Review of Ofgem's RIIO-2 Draft Determinations proposal on ongoing efficiency

Prepared for
Scottish and Southern Electricity
Networks

August 2022

Figure 3.1 SSEN's absence levels

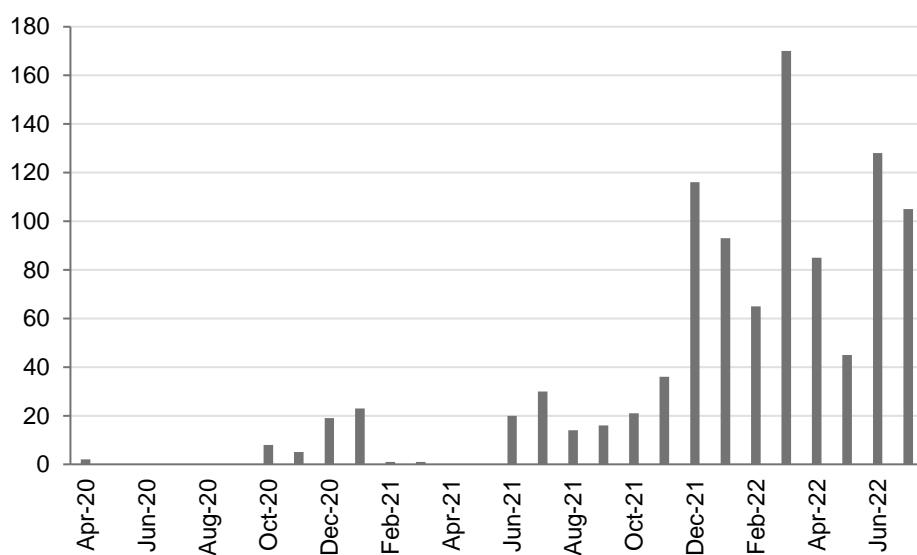
- 3.16 The COVID-19 pandemic had the potential (and still does) to affect productivity in the sector: workers become ill, isolate at home, or develop long COVID.

DNOs are affected by these same issues, and have now had experience of the impact for c. 2.5 years. Data from SSEN's COVID absence reporting shows high absences in 2022, demonstrating that the pandemic is far from over (see Figure 3.1).
